SEALED BID FOR: East Hickman Pump Station Expansion and
Rehabilitation Design
Phase 2 Wastewater System Improvements
Bid No. 65-2025

**ADDENDUM #3**Bid Number: **#65-2025**

Subject: East Hickman Pump Station Expansion and Rehabilitation Design – Phase 2 Wastewater System Improvements

- A. Drawing M-008 – Mechanical Pump Station – Detail A
 a. Replace Detail A on Drawings M-008 with the following detail.

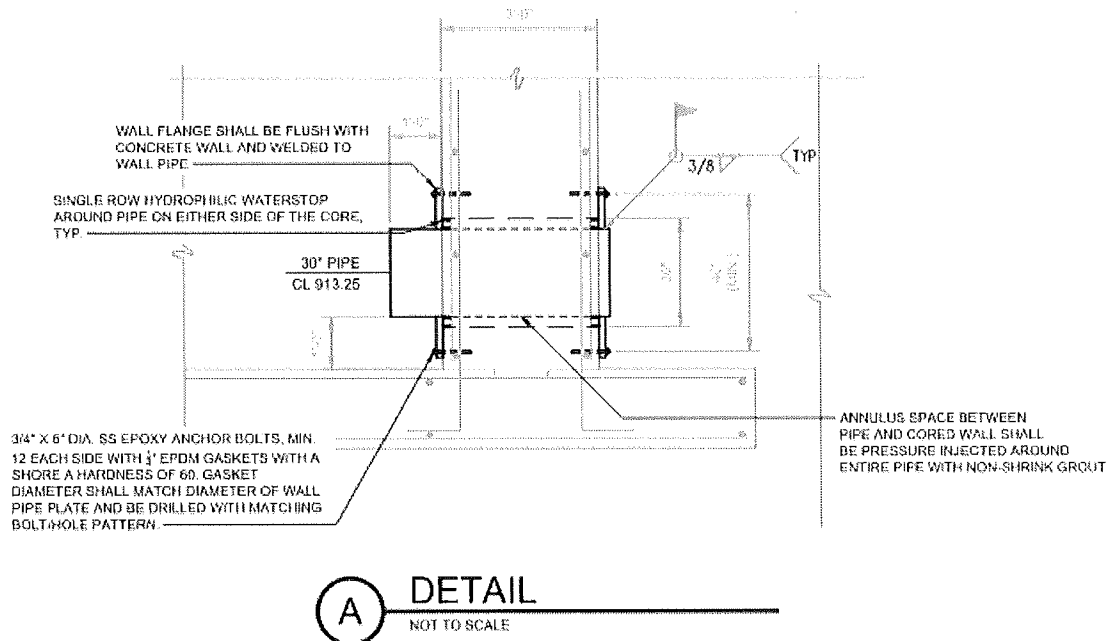
29.	It appears the 30" Wall Pipes with face plate flanges at the wall are to be a custom welded fabrication with no link seal at the cored openings as may be found in a typical thru-wall installation (reference Detail A on M-008). It is difficult to properly weld ductile iron pipe in this manner; therefore, please advise/confirm if the wall piping and the welded plate is to be ductile iron, or if stainless steel or painted carbon piping will be acceptable in this application. The installation will require at least one of the flanges to be field welded in order to limit the size of the opening as shown.	<p>The 30-inch 'wall pipe' section shall be carbon steel with a minimum thickness of 0.34 inches and face plates shall have a minimum thickness of 0.50 inches. The interior of the wall piece shall be coated with Protecto 401 or approved equal and touched up after welded in place. The plain end of the steel pipe shall be sized to join either the MJ plug valve or push on DIP as shown on Drawing M-007.</p> <p>See revised Detail A from Drawing M-008 included in this addendum.</p>
